HORSHAM DISTRICT COUNCIL CONSULTATION

| LOCATION: | Land To The North and South of Mercer Road Warnham |
| DESCRIPTION: | Redevelopment of the site to provide 304 residential units, parking, a retail unit, public car park, public open space, attenuation basins and landscaping |
| REFERENCE: | DC/25/0151 |

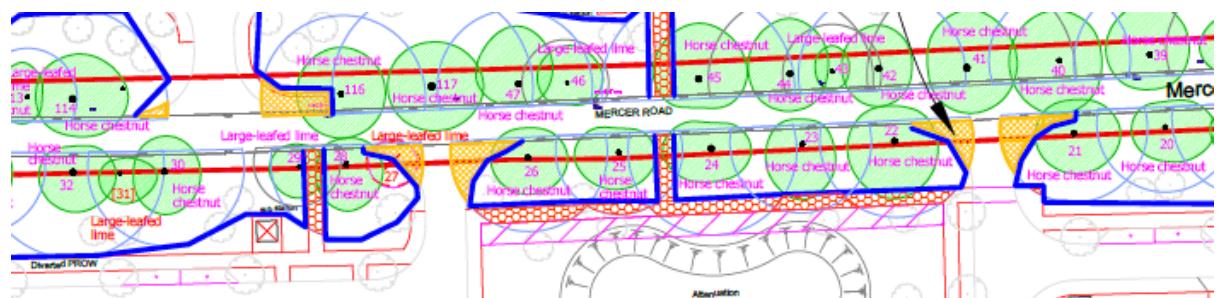
It is noted that the RPA incursions do appear to be within acceptable limits, (below 20%) and alternative construction methods such as no dig above-ground build with porous surfacing have been proposed for the majority of the RPA incursions. However, there are instances where the "technical solutions" proposed to address RPA incursions are to cut the roots under Arb supervision; I would not consider this to be a suitable technical

solution to ensure the satisfactory and long-term retention of the affected trees, which due to their roadside location are of high landscape value. It is acknowledged that the areas where root severance is proposed relate to the access points into the site, which would likely need to be built to an adoptable standard to satisfy the requirements of the local Highway's Authority. The overriding justification provided for this method of construction within the RPA is advised at Para 2.4 of the AIR.

While it is accepted that the site needs to be accessed, however, in my opinion, given the green field nature of the site coupled with the likely harm to the affected trees as a result of the extent of the root severance within their RPAs; even if kept to less than 20% of the total RPA and maintained at a depth of no more than 400mm. I would not consider that this reason appropriately justifies how the works for the new access in the RPAs are proposed. As the harm to the impacted trees could be lessened by way of selected tree removal, modification or omission of the access points into the site.

For example, where the new accesses into the southern part of the site pass through the Lime and Horse Chestnut Avenue on Mercers Road. Trees T22, and T26, both Horse chestnuts could be removed and replaced with instant impact extra heavy standard-size trees of the same species to allow for the access to be moved further away from T26, and T21 and reduce the overall impact and likely harm as a result of the root severance proposed to trees T21 and T28.

This would also be the case for the access into the northern section of the site where T116, Horse chestnut could be removed and then replaced. While it is acknowledged that the Lime and Horse chestnut avenue is an important landscape feature that makes a significant and positive contribution to the character and amenities of the area, and although it is regrettable to lose mature trees to development, I am not of the view that the removal of 3 trees from the avenue would give rise to an unacceptable loss of amenity to the area. The reasoning behind this is that the bulk of the avenue would be retained and over time as the replacement trees grow into maturity this harm would be lessened. In addition, this action would lessen the development impacts on trees T21, T28 and T114, and reduce the need for any significant root severance with their RPAs.

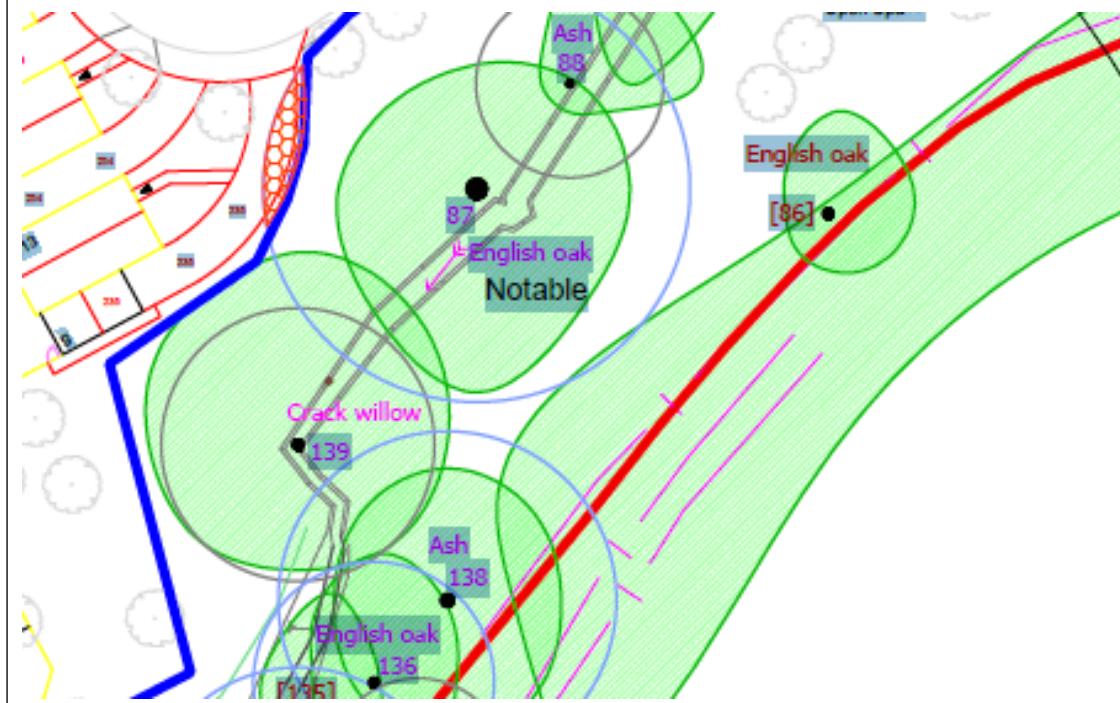
Where the northeast section of the site is proposed to be accessed from the east on Langhurst Wood Road there are RPA issues. In this area, the new access point encroaches on the RPA of the Wych elm T96 by 12.7%. As with the other access points the “*technical solution*” proposed to address the incursion into the RPA is to cut the roots; this doesn’t satisfactorily meet with requirements of the BS and will likely result in substantial harm to the tree.

T96 forms part of a line of Wych elms, that abut Langhurst Wood Road. Due to their roadside location, the trees are readily visible when viewed from within the public domain. This line of trees makes a significant contribution to the amenity value of the area, to which T96 makes a valuable contribution. Amendments could be made to reduce the impact on T96 as a result of the proposed development. Whereby, consideration could be given to move the proposed accesses further to the south, outside of the RPA of T96 or omit this access completely and make use of the western access into this part of the site.

If a solution cannot be found for the access arrangements into this part of the site. I would recommend that the scheme be refused on the grounds of harm to trees of significant historical, cultural, habitat, and landscape value, and due to the proposed construction method, and location of the new access not satisfactorily meeting the minimum requirements of the current industry standard BS 5837 .
